UNITED STATES PATENT AND TRADEMARK OFFICE

10/672,370

Laurence E. Dahners

DETAILED ACTION

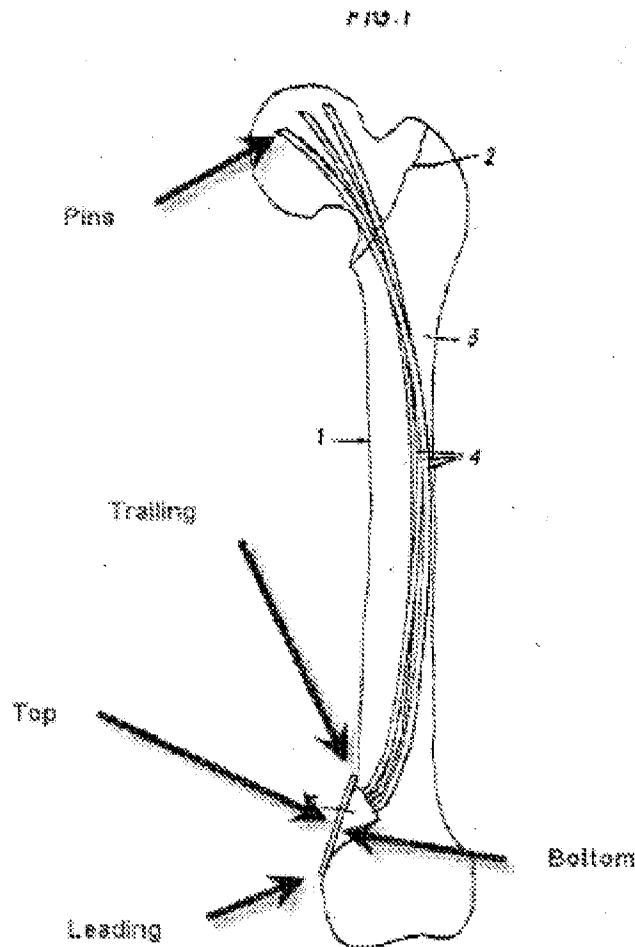
2. Claim 38 is rejected under 35 U.S.C. 103(a) as being unpatentable over Ender (US Patent 4,467,793).

Ender discloses an intrafocal plate (Fig. 1) for securing bone fractures comprising: an elongate plate (5) element defining a leading ending (see modified fig. 1 below), a trailing end (see modified fig. 1 below), an intermediate location between the leading and trailing ends, an overhanging heel (17, see Fig. 7) toward the trailing end configured to prevent over reduction of a fracture and to stabilize the intrafocal plate when inserted into a fracture site of a bone, a top surface (7), and a bottom surface that is configured to engage an outer surface of a bone; and a resilient body element (4) (col. 1, lines 19-20) extending downwardly from the bottom surface of the elongate plate element and in a lengthwise direction relative to the elongate plate element beyond the terminal end of the resilient plate element (Fig. 1), the resilient body extending from the intermediate location (see modified fig. 1 below) of the elongate plate element such that

the overhanging heel of the elongate plate element is located between the resilient body element (4) and the trailing end of the elongate plate element (see modified fig. 1 below).

Ender fails to teach that the resilient body element formed as an integral, single piece with the elongate plate element.

It would have been obvious to one having ordinary skill in the art at the time the invention was made to construct the resilient body element formed as an integral, single piece with the elongate plate element, since it has been held that forming various elements in one piece involves only routine skill in the art. *Howard v, Detroit Stove Works*, 150 U.S. 164 (1893).

Fig. 5

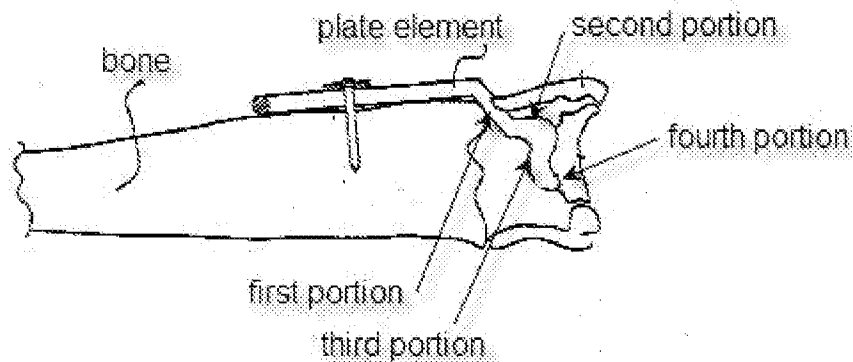
Ender fails to teach that the body element has a sinuous shape in a first plane according to a side elevation view of the body element, wherein the sinuous shape extending downwardly and outwardly from the bottom surface of the elongate plate element in the first plane, wherein the body element has a first portion, a second portion a third portion and a fourth portion, wherein the first portion curves away from the plate element, the second portion curves toward the plate element, the third portion curves away from the plate element and the fourth portion curves toward the plate element; and the body element defining a straight shape according to a top elevation view of the body element.

Medoff teaches a body element (Fig. 3) has a sinuous shape in a first plane according to a side elevation view (Fig. 3) of the body element, wherein the sinuous shape extending downwardly and outwardly in the first plane (Fig. 3), wherein the body element has a first portion, a second portion a third portion and a fourth portion for fixation of one or more bone fragments (abstract; see Fig. 5), wherein the first portion curves away from the first part (41, may be considered as a plate element) (see modified Fig. 5 below), the second portion curves toward the plate element (see modified Fig. 5 below), the third portion curves away from the plate element (see modified Fig. 5 below) and the fourth portion curves toward the plate element (see modified Fig. 5 below); and the body element defining a straight shape according to a top elevation view (Fig. 2) of the body element.

It would have been obvious to one having ordinary skill in the art at the time the invention was made to construct the resilient body element of Ender from a sinuous shape from first, second, third and fourth curved portions extending downwardly and outwardly from the bottom surface of the plate in view of Medoff for enhancing fixation of one or more bone fragments.
